Enquiries: Chris Bryant  
Direct Phone: (07) 5433 2484  
Our Ref: DA/2024/4695  
Your Ref: LR2440  
Date: 6 February 2025

**Re: ADDITIONAL INFORMATION REQUIREMENTS**  
**Development Application No.: DA/2024/4695**  
**Property Location: 25 Marine Parade, Redcliffe**  
**Property Description: Lot 427 SL 1339**  
**Development Type: Material Change of Use - Development Permit for Multiple Dwelling (5 Dwellings)**

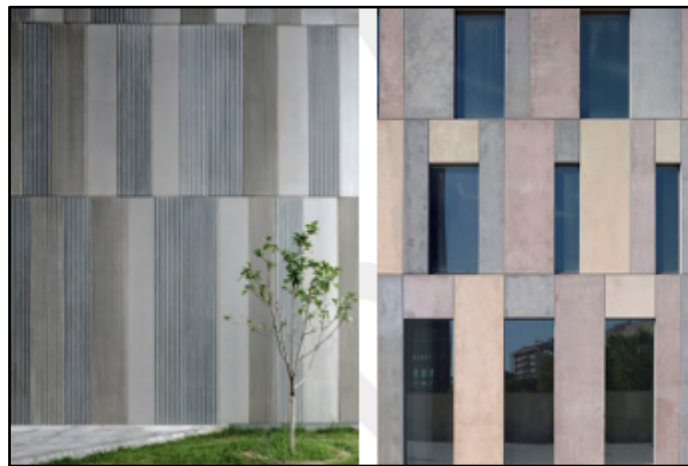
1. The revised proposal plans indicate that the balcony for the First Floor Dwelling has been extended along the southern side elevation (previously roof to the Ground Floor only). The revised balcony is oriented directly towards the POS of the Dwellings located on 17 Marine Parade which will introduce overlooking and therefore perceived impacts on privacy and amenity.

Accordingly, please provide amended plans demonstrating how the southern side elevation of the First Floor Dwelling balcony is to be screened, or alternatively, remove this portion of the balcony.

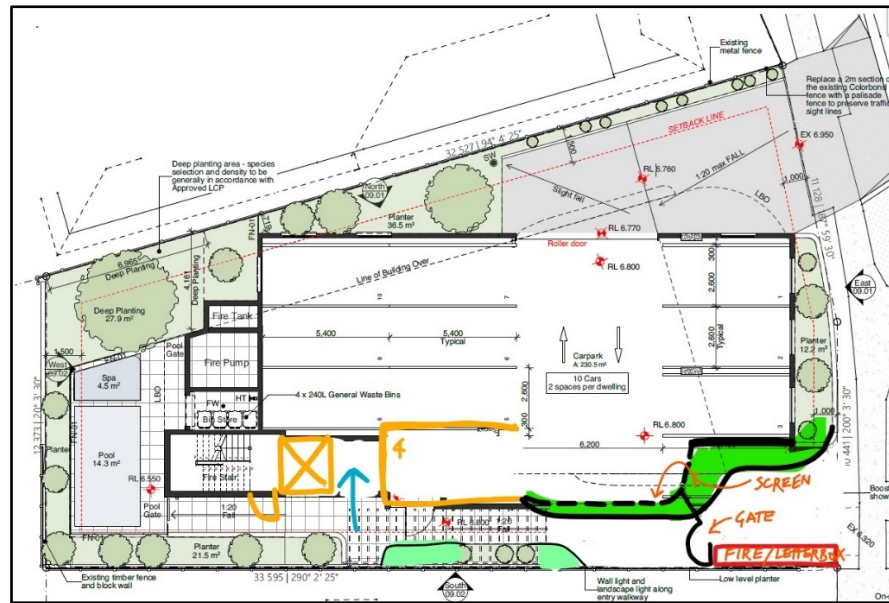
- c. The presentation of the upper floor of the building facing west requires further design interventions. Introduce fixed and operable screening, material articulation, expressive roof or other devices to achieve tonal and 3d variation to the area circled yellow below. Suggested outcomes are provided adjacent.
